## **PROPOSED COMMERCIAL DEVELOPMENT, 538 KARANGAHAPE ROAD, AUCKLAND SECTION 92 (BUN60427502) – TRAFFIC ENGINEERING RESPONSE**

Following a recent resource consent application for a proposed commercial building on the subject site at 538 Karangahape Road, Auckland Council have issued a Section 92 Request for Further Information. Commute met with Auckland Council and Auckland Transport on 12 February 2024 to discuss the Section 92 requests.

Figure 2: Accessible Parking Spaces Pedestrian Route to Elevators

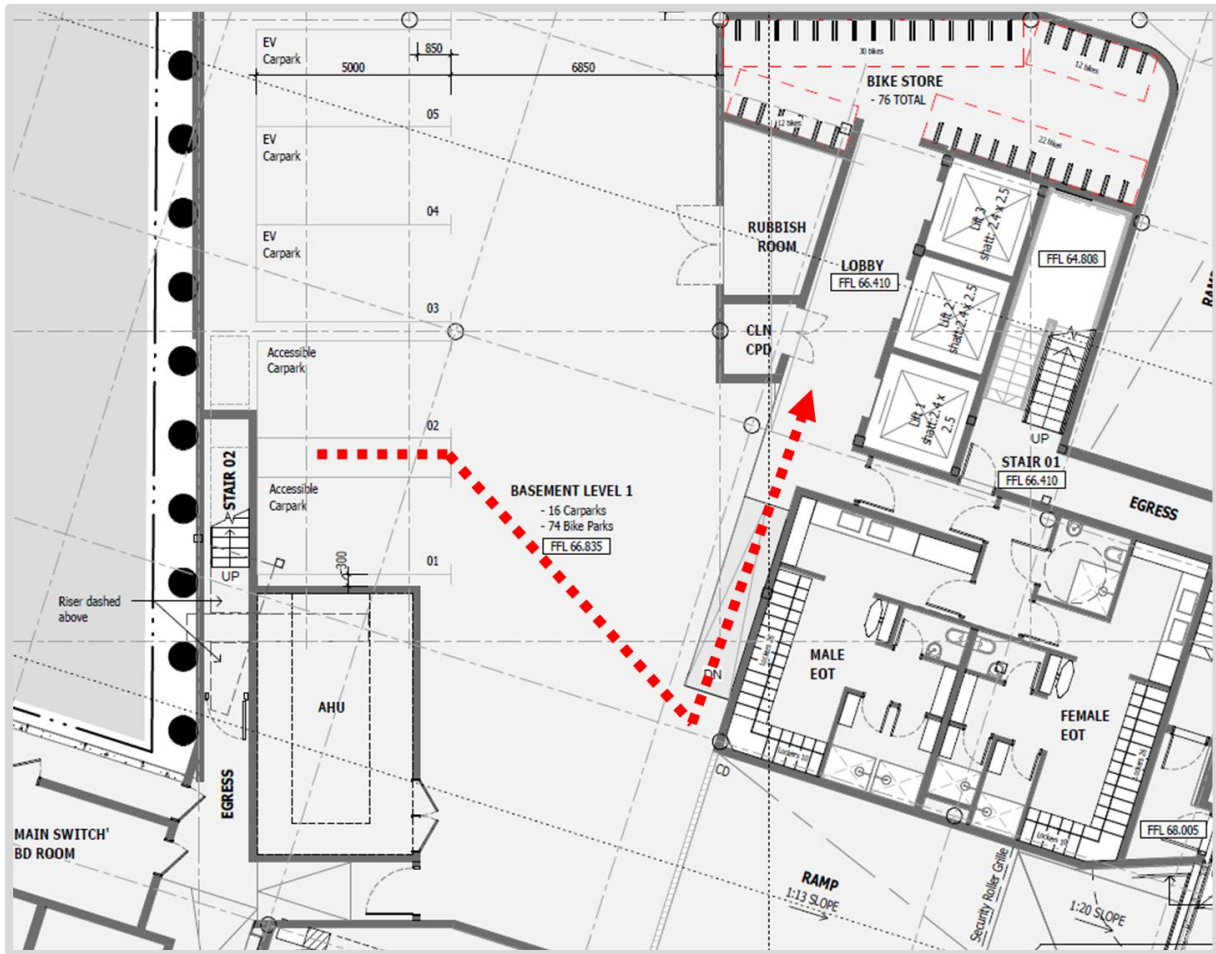
- 21. NZS 4121-2001 requirement 5.7.2 states that people with disabilities shall not have to pass behind parked cars when moving to an accessible route or when approaching from an entrance. It appears from the site plan that access between parking space #02 and the nearest building entrances would necessitate passing behind a parked car in space #01 (if occupied). It is thus recommend that consideration should be given to an alternative site layout to negate this problem.**

The entrance is located centrally to the building, across the manoeuvring aisle from the accessible spaces. As such, pedestrians will not be required to walk behind parked vehicles and therefore the arrangement is considered to be satisfactory. Figure 2 demonstrates these pedestrian paths.

**Figure 3: Proposed Access Cross-Section**

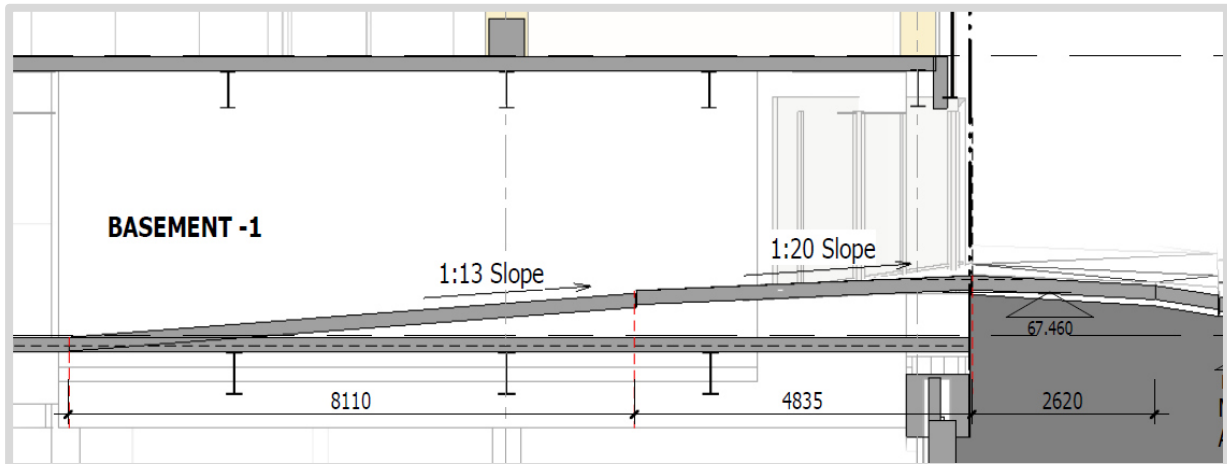
23. *Please provide long-sections of the proposed ramp from the vehicle crossing showing safety platform and ramp gradient. It is noted that the proposed roading plan shows that 1:8 gradient is proposed for the safety platform infringing the maximum requirement of 1:20.*

Figure 3 shows a cross-section of the proposed ramp at the site access.

It is noted that the 1:20 section at the site boundary has increased in length from the 4.4 metres in the Commute Report to now be 4.8 metres long. The architectural drawing package has been updated to reflect this change.

**Figure 4: AS/NZS 2890.1:2004 Visibility Splay at Site Access**

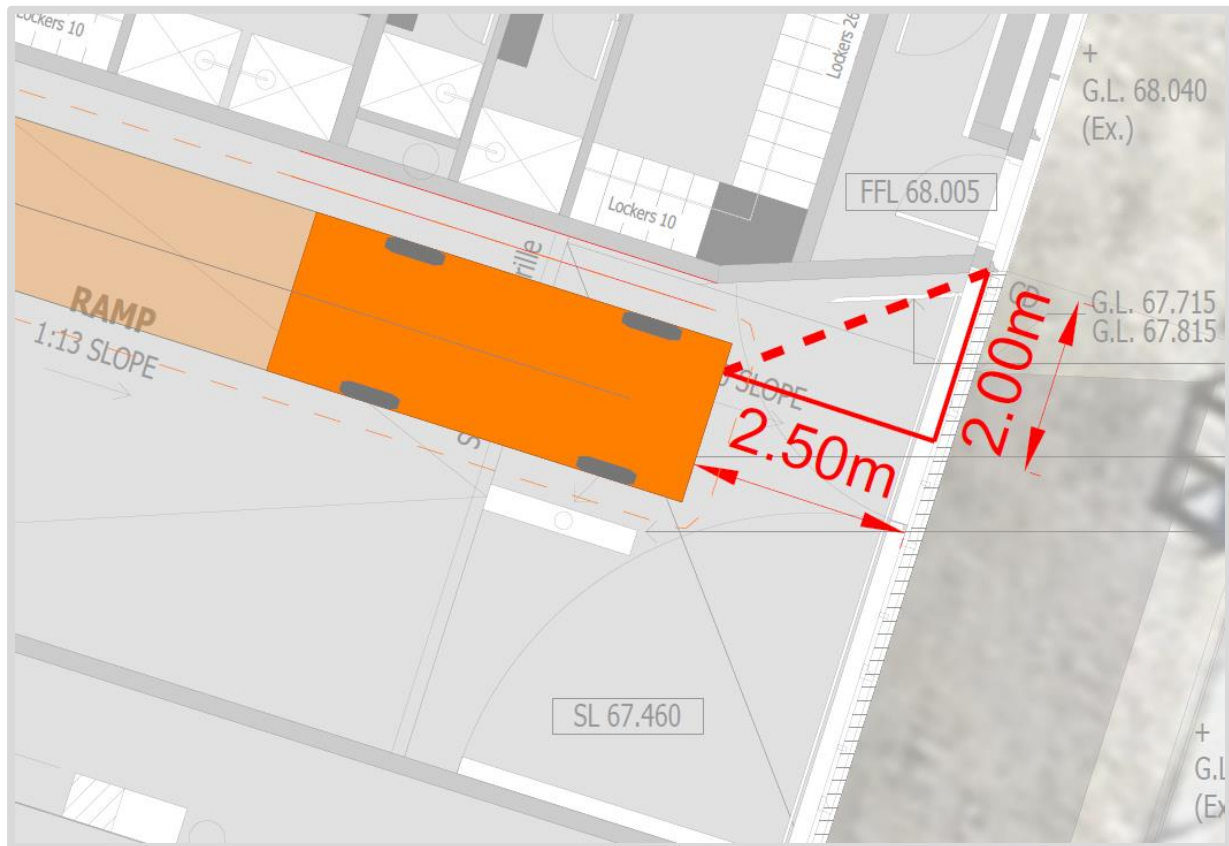
**25. The transport assessment notes a vehicle trip generation of over 2000 vehicles per day to the site. There is no back berm present between the property boundary and the public footpath. Based on the high trip generation rate and the lack of back berm, AT is concerned that pedestrian and vehicle intervisibility is affected. The traffic assessment notes that a pedestrian visibility splay is provided on the northern side of the proposed vehicle crossing to assist in achieving pedestrian and vehicle intervisibility. The splay is proposed at 2.9m x 1.1m. Based on the proposed trip generation rates, the proximity of the crossing to an intersection and non-compliance with the required vehicles waiting platform, the size of the pedestrian visibility splay provided is considered insufficient to address pedestrian safety concerns. Please provide additional information in accordance with E27.8.2(8)(a) on how pedestrian and vehicle intervisibility at the proposed vehicle crossing can be avoided, remedied or mitigated.**

**Advice note: The NZTA Pedestrian Planning and Design Guideline recommends a 5m x 2m pedestrian visibility splay for vehicles crossings generating more than 200 vehicles trips per day. This development will exceed the 200-trip number.**

The NZTA Pedestrian Planning and Design Guideline states that these larger splays should be installed in areas with "high pedestrian flows and more than 200 expected daily vehicle access manoeuvres". As discussed above, the expected daily vehicle access manoeuvres are less than 200, and the expected pedestrian flows across the vehicle access are not considered to be in the 'high' category ('high' pedestrian flows are considered to be in more concentrated areas such as near train stations or busy intersections and roads in metropolitan areas such as Karangahape Road, not along Gundry Street).

The AS/NZS 2890.1:2004 shows a 2.5m x 2.0m visibility splay being provided at the site entrance. It should be noted that the splay is not specified in the standards as being a physical splay in the building, however it does imply that the 2.5m x 2.0m visibility splay can be achieved at the site boundary. Figure 4 below shows an exiting vehicle in a realistic position at the site access (with a 300mm kerb and 300mm vehicle body clearance to the kerb), and as can be seen a 2.5m x 2.0m visibility splay can be achieved. This is considered to be satisfactory to achieve a safe intervisibility window between pedestrians and vehicles.

In regard to the proposed waiting platform, which measures 4.4 metres in length and slopes down toward the site boundary, it is noted that an 85<sup>th</sup> percentile vehicle will be able to have its wheels fully positioned on the 1:20 (5%) gradient while remaining within the site boundary (front of body to rear wheels measures 3.72 metres as per Figure E27.6.3.3.2 of the Unitary Plan). It is understood that the intent of the Unitary Plan rule to provide 6.0 metres is for heavy vehicles with longer wheelbases, and as no heavy vehicles will be accessing the site, the 4.4 metre long platform is considered to be appropriate such that it would not impact pedestrian intervisibility.

Figure:  
**A2**

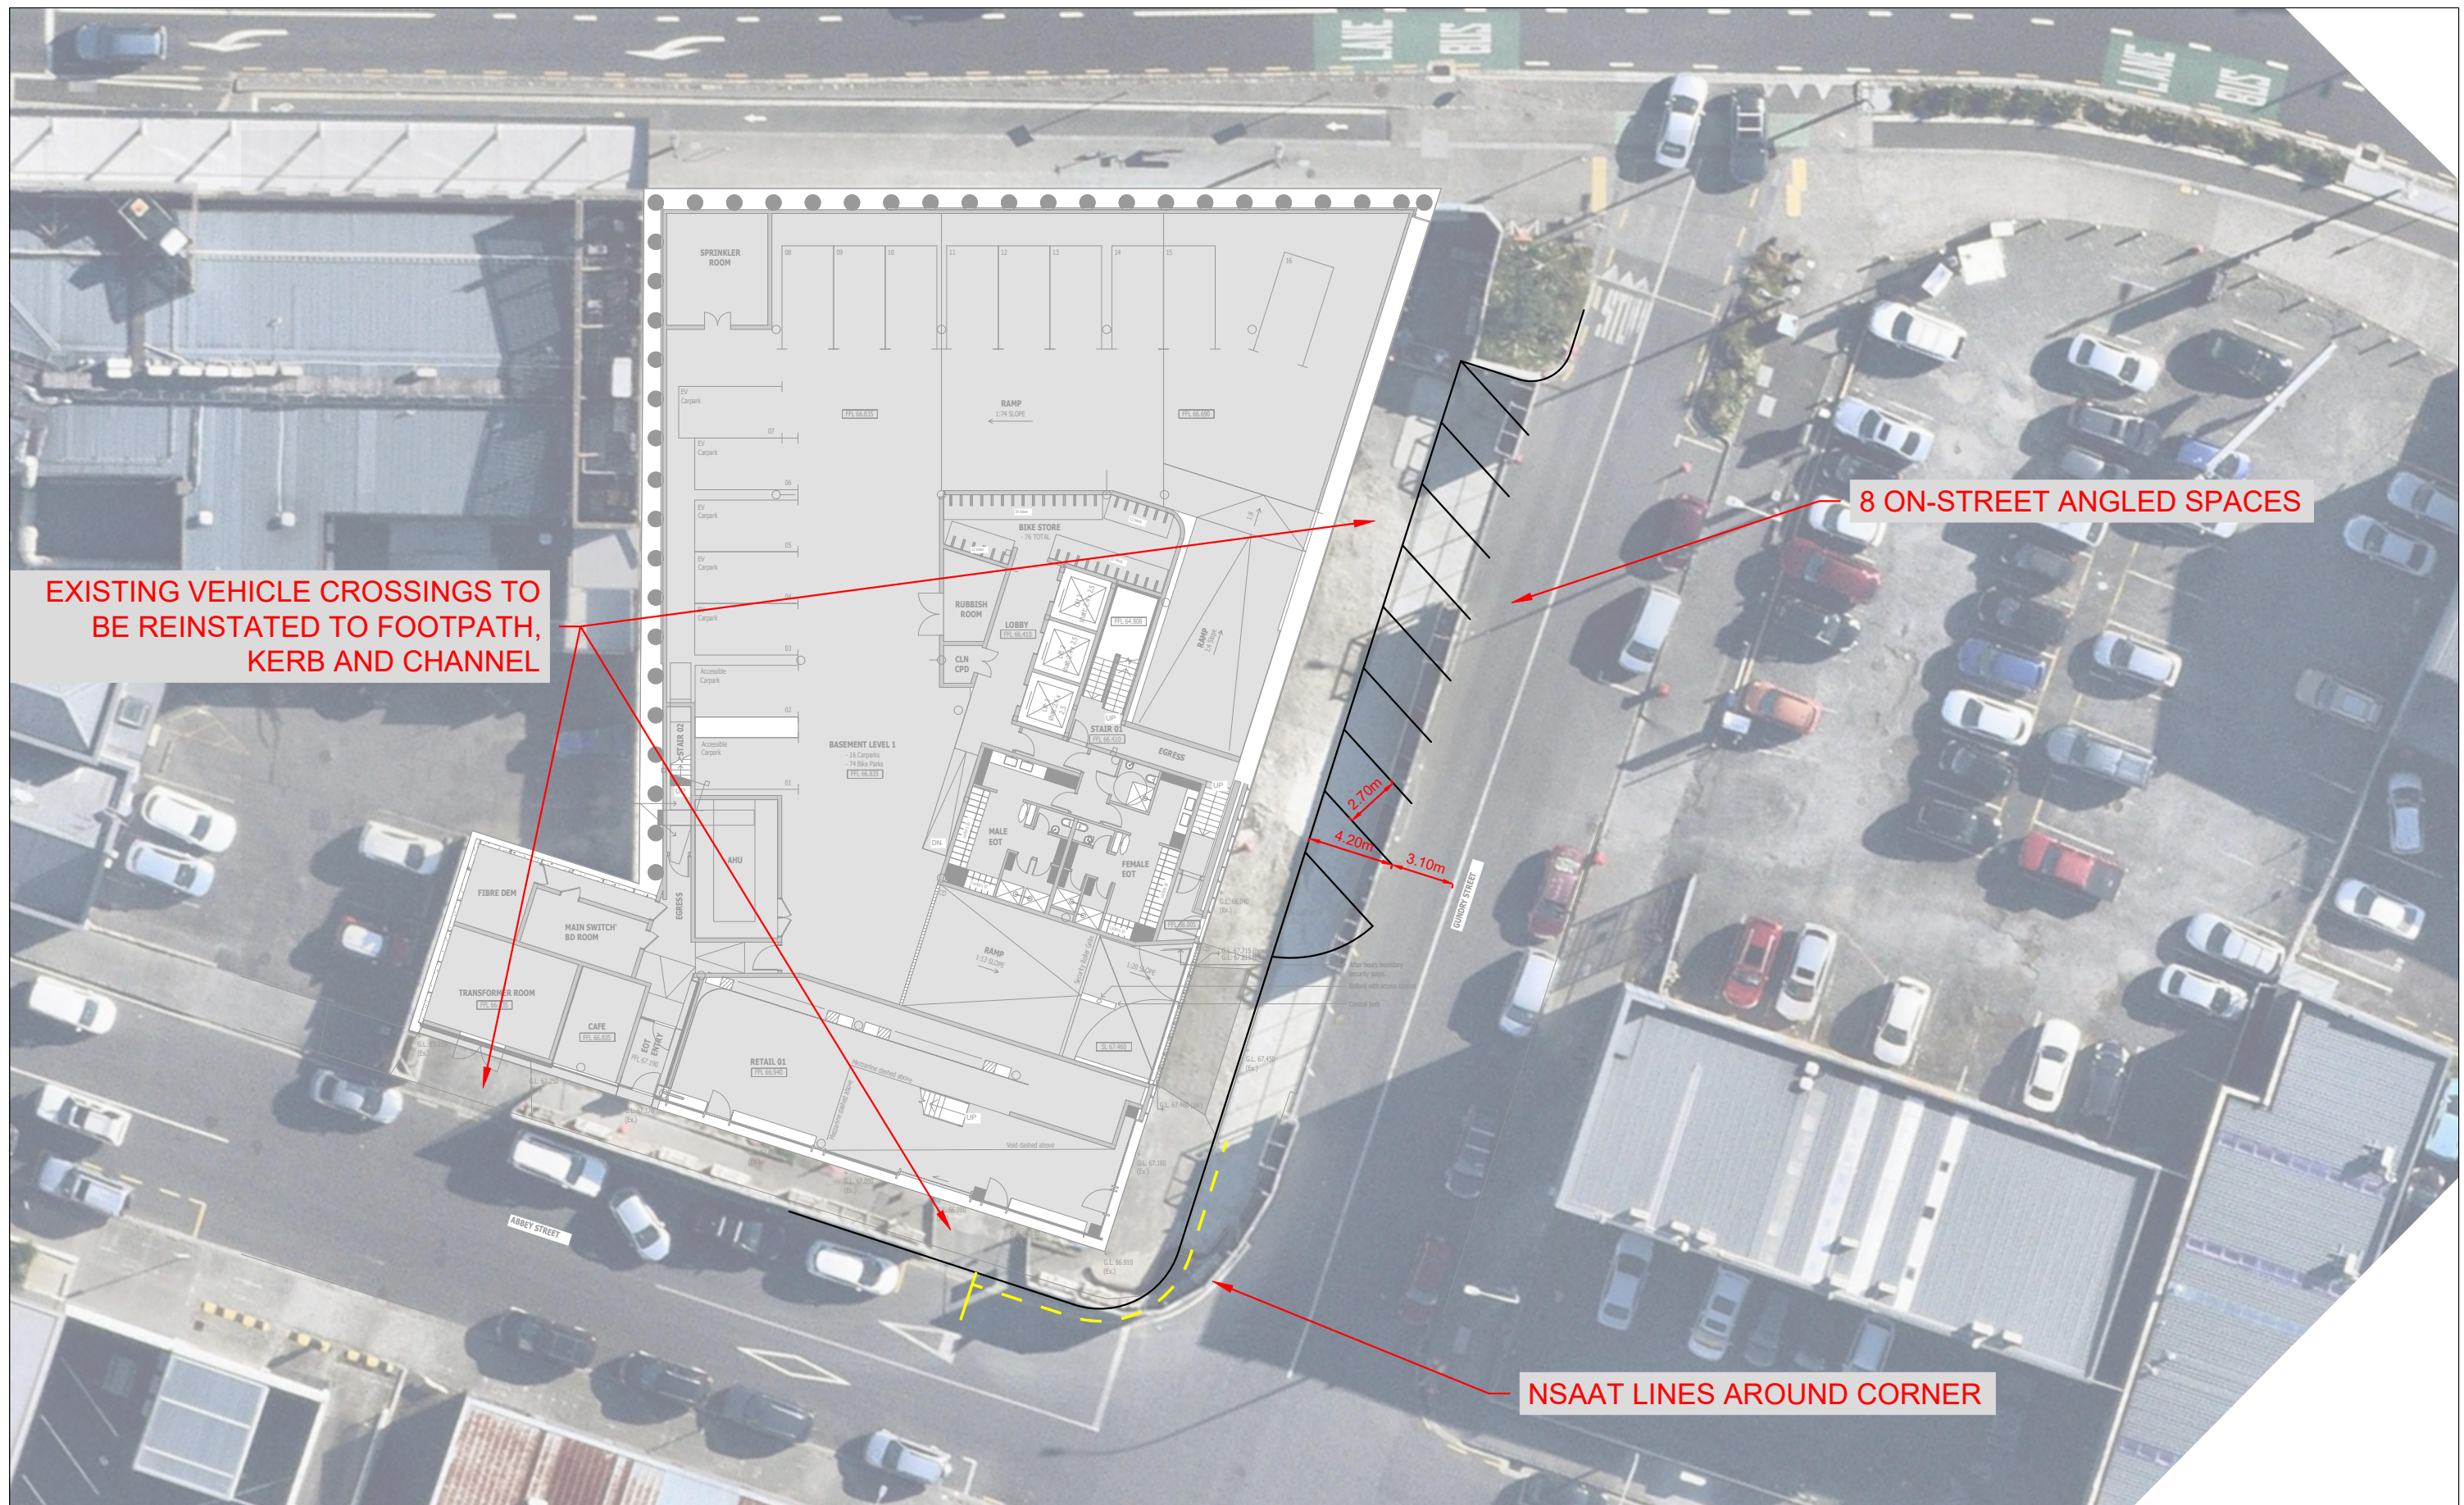
**a. Please confirm if the car parking spaces proposed to be removed as a result of the new vehicle crossing will be reinstated.**

**b. If these spaces will not be reinstated, please provide an assessment in accordance with Objective E27.2(3) Policy E27.3.3(f) of the effects of the loss of on-street parking arrangement on the western side of Gundry Street.**

Figure A2 in Appendix A shows the previous on-street parking arrangement on Gundry Street, and Figure A3 shows a conceptual design of Gundry Street in the vicinity of the site, with how the finished on-street parking arrangement may look like. The design results in 8 on-street parking spaces being provided, which is a net increase of one parking space compared with the previous arrangement. Waste loading will occur in front of the proposed vehicle crossing on Gundry Street.
